**SECTION 00 91 03
ADDENDUM NO. 3**

PROJECT: VILLAGE HALL AV IMPROVEMENTS
123 MADISON STREET
OAK PARK, ILLINOIS 60302

PROJECT NO: 24-475-1560

TA-020.02

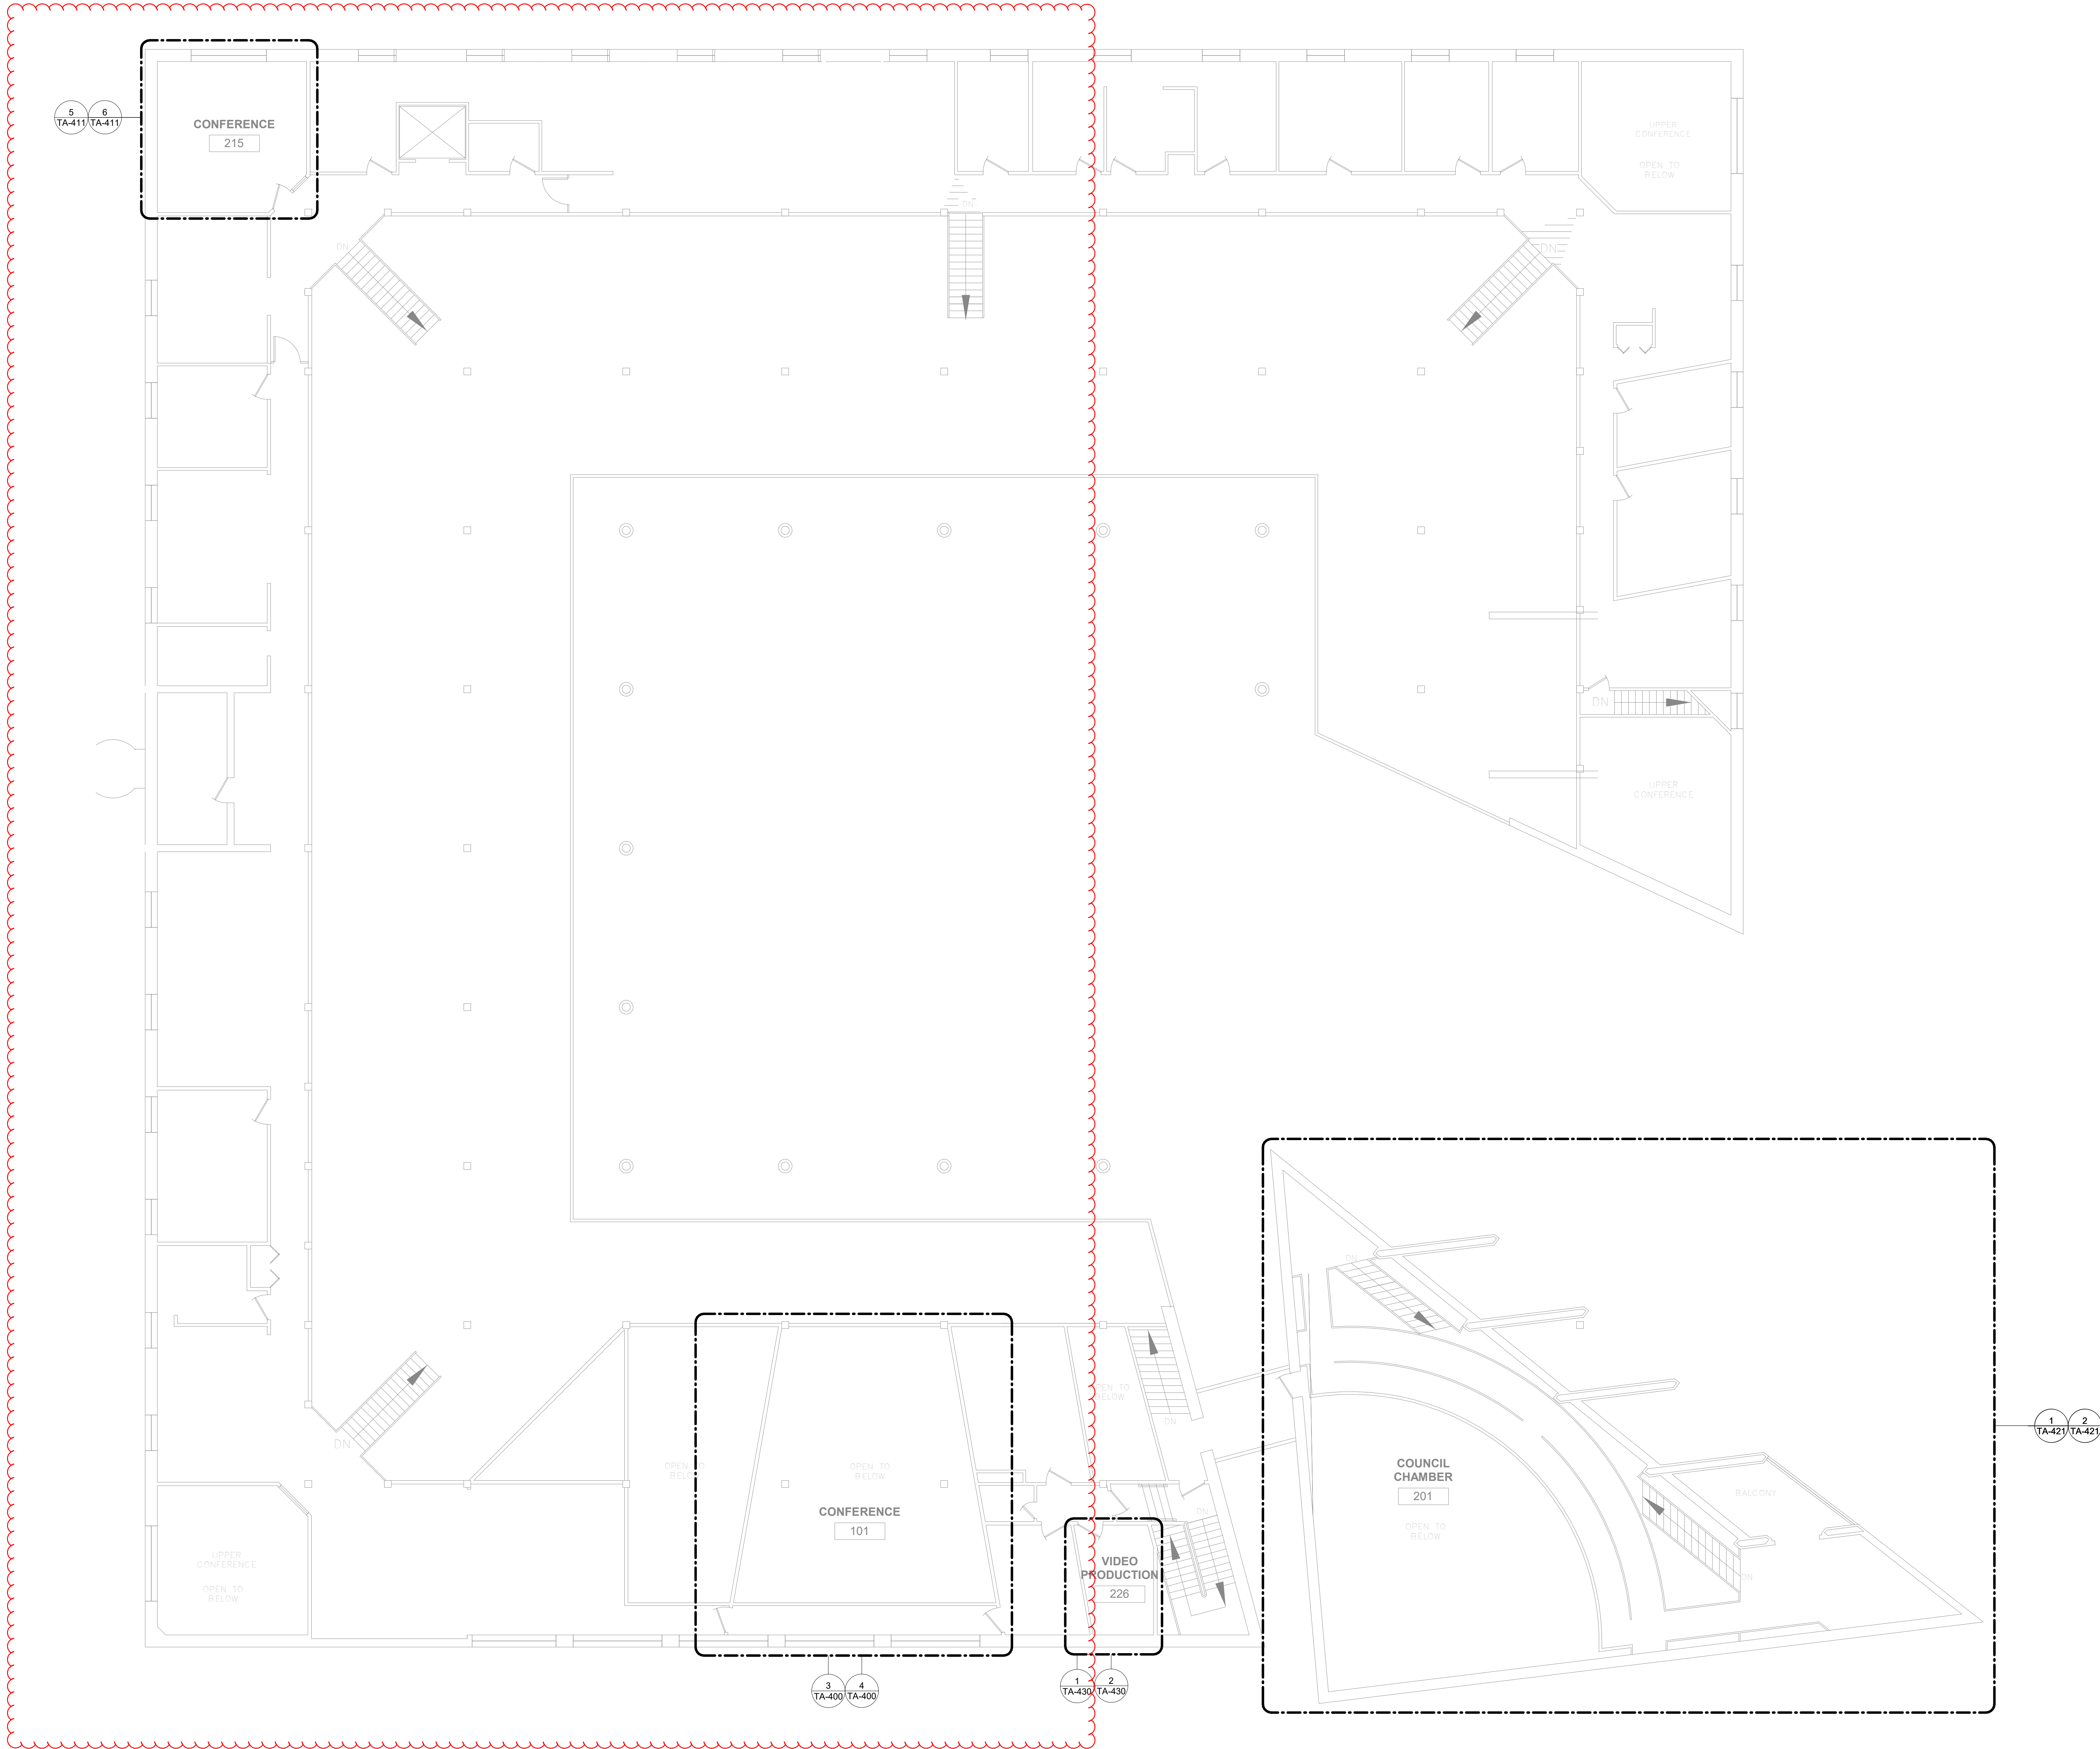
CEILING LOUDSPEAKER MODEL NUMBER CHANGED AND NOTE ABOUT
ADDITIONAL CEILING SUPPORTS ADDED.

TA-900

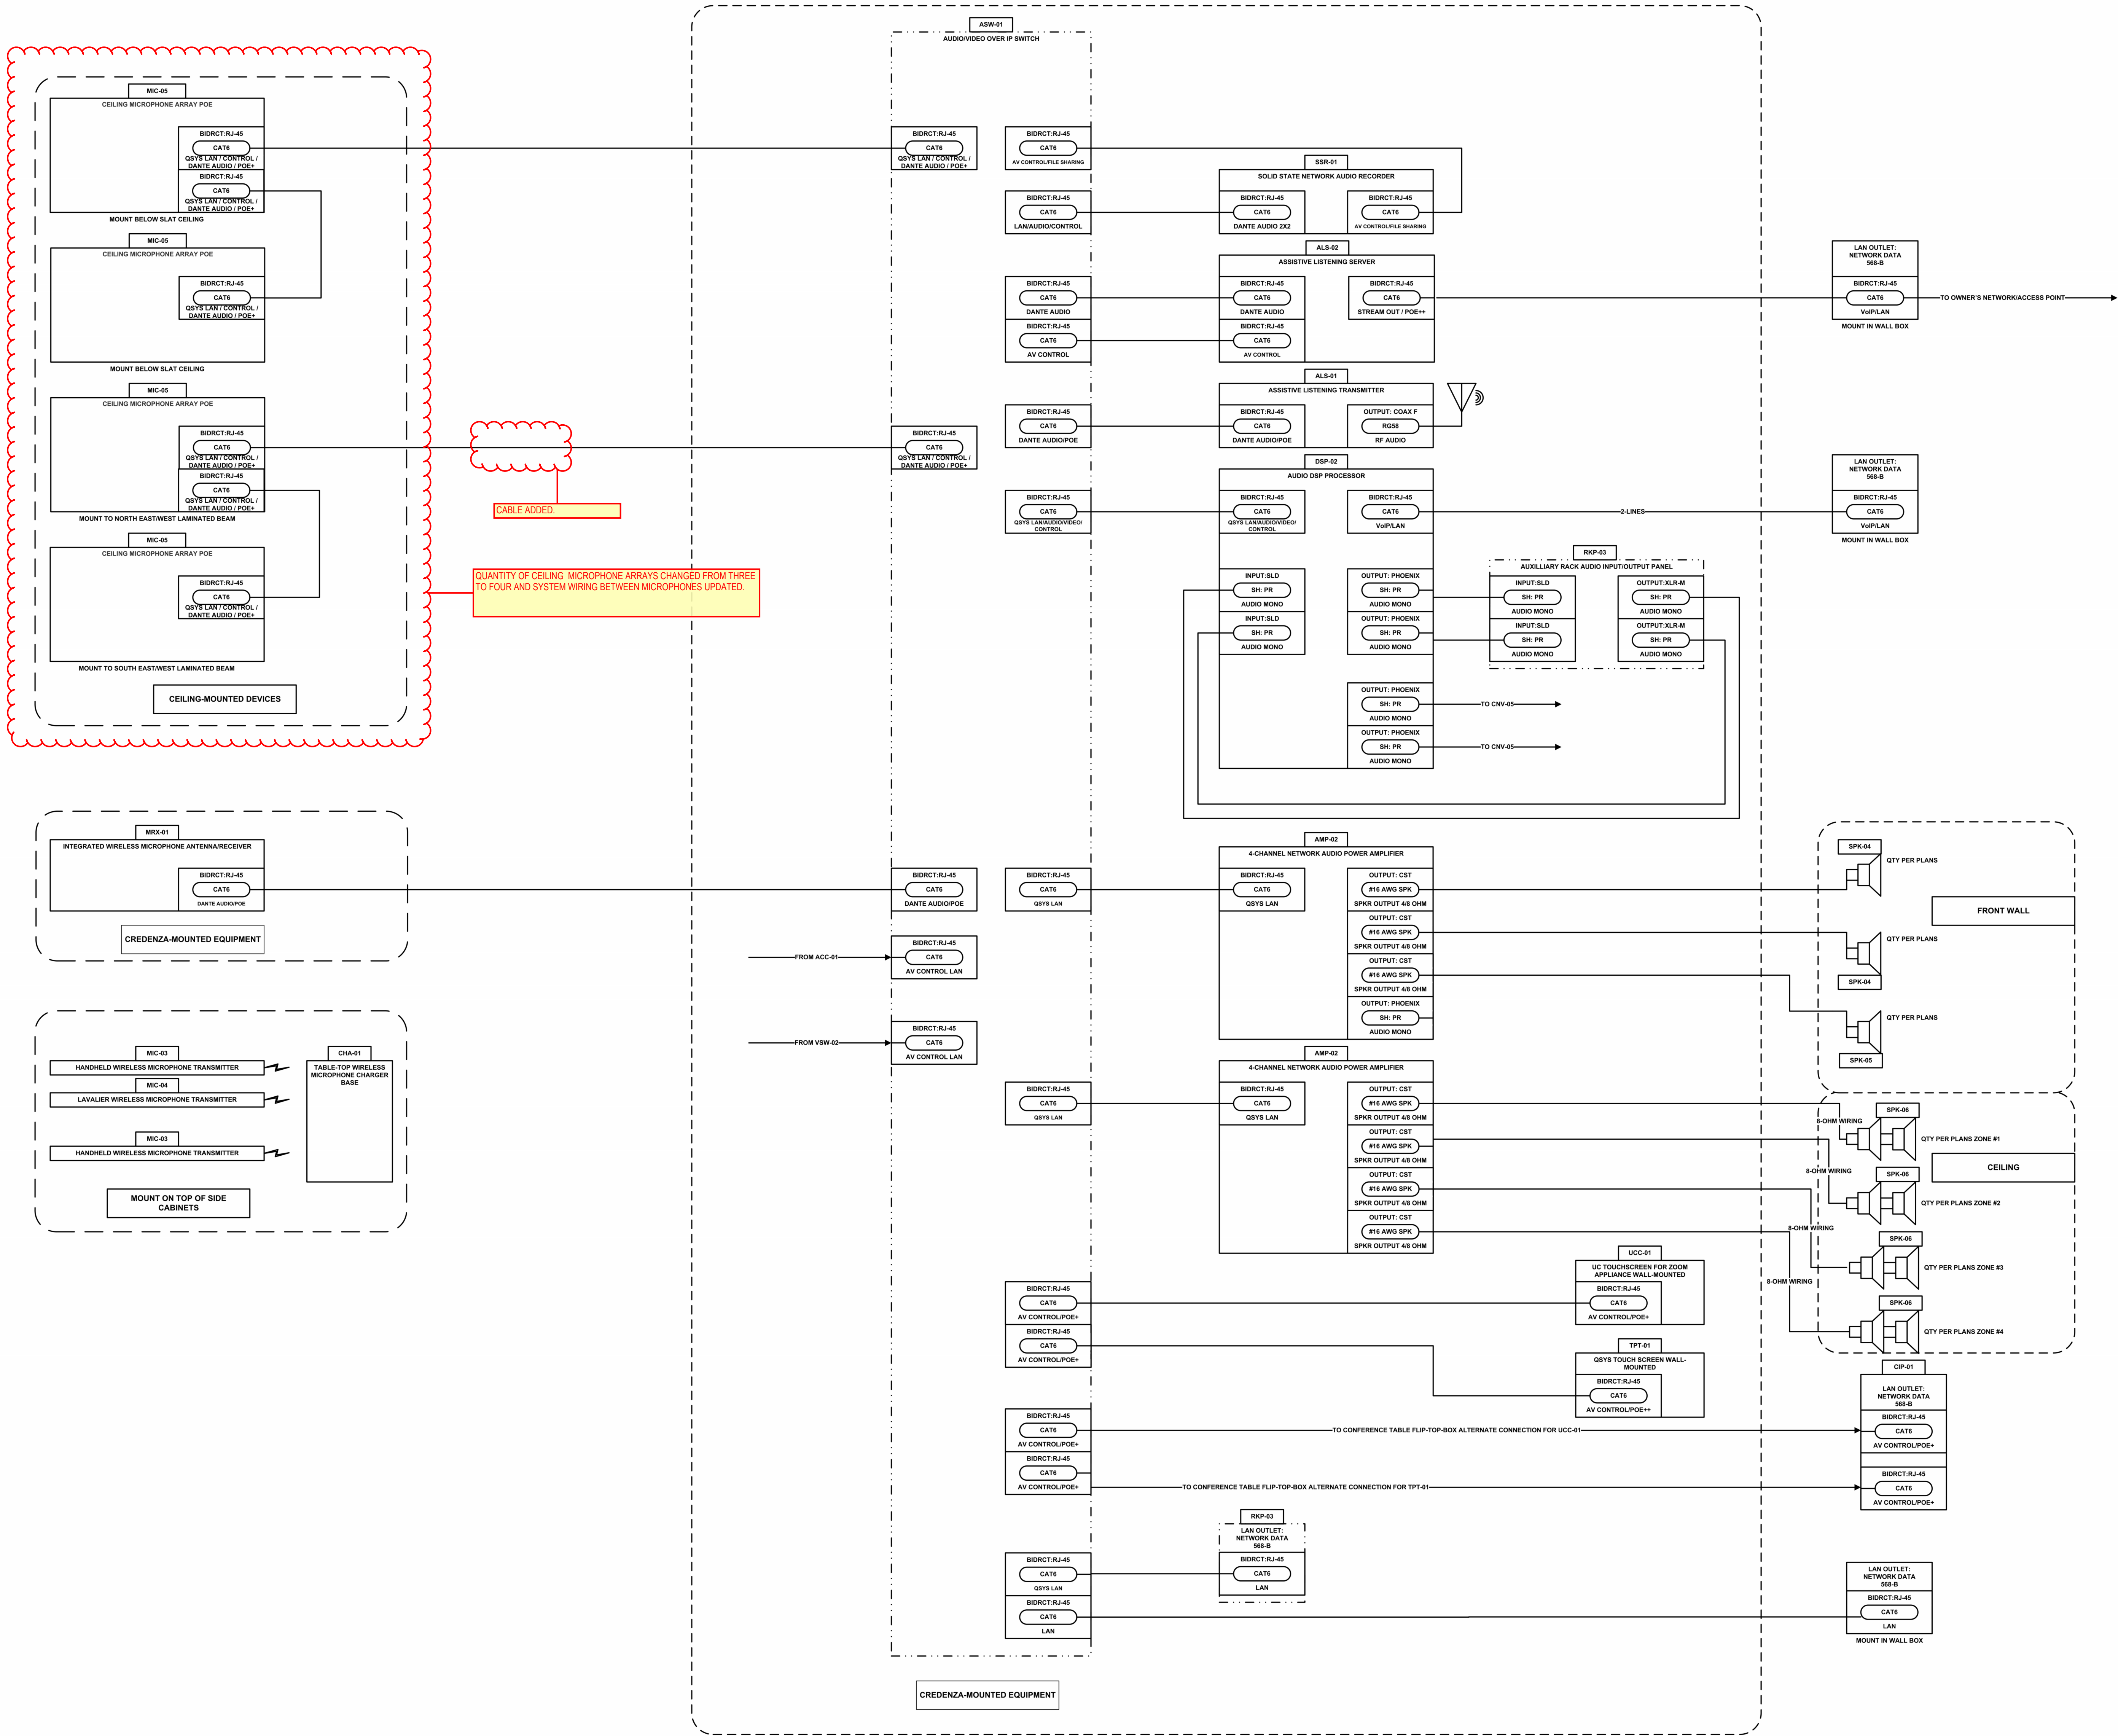
Question: Drawing TA-901 is labeled Video Signal Flow but it contains the identical content shown in drawing TA-900, labeled Audio Signal Flow. We need the information that was intended for TA-901 in order to provide a quote for Large Conference Room 101. Please advise.

Response: Drawings TA-900 and TA-901 have been revised and reissued as a part of this addendum.
